Product Change Notice (PCN)

PCN Number: **PCN-0456173R-01**

Product(s) Affected: *PJ-040DH*

PREVIOUS CUI DEVICES DETAIL / IMAGE	NEW CUI DEVICES DETAIL / IMAGE

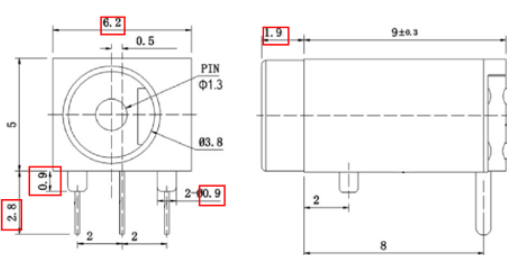
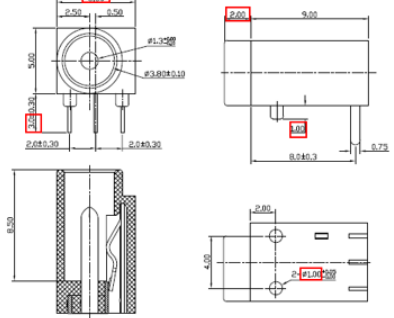
Description of Change: *New Factory Location. Product re-engineered for improved manufacturability and production yield. See image below for reference and check CUI Devices website for updated drawing. Cosmetic differences may be visible and not affect the form fit and function of the product.*

<p>Recommended PCB Layout Top View</p>	 <p>Recommended PCB Layout Top View</p>

PREVIOUS CUI DEVICES DETAIL / IMAGE			NEW CUI DEVICES DETAIL / IMAGE		
DESCRIPTION	MATERIAL	PLATING/COLOR	DESCRIPTION	MATERIAL	PLATING/COLOR
center pin	brass	silver	center pin	brass	silver
terminal 1	brass t=0.25	silver	terminal 1	brass t=0.25	silver
terminal 2	brass t=0.25	silver	terminal 2	SUS301 t=0.25	silver
terminal 3	brass t=0.25	silver	terminal 3	brass t=0.25	silver
cover	PBT (UL94V-0)	black	housing	PA66 (UL94V-0)	black
housing	PBT (UL94V-0)	black

<p>MATING PLUG Jack Insertion Depth: 8.0 mm</p>	 <p>MATING PLUG Jack Insertion Depth: 8.5 mm</p>
---	--
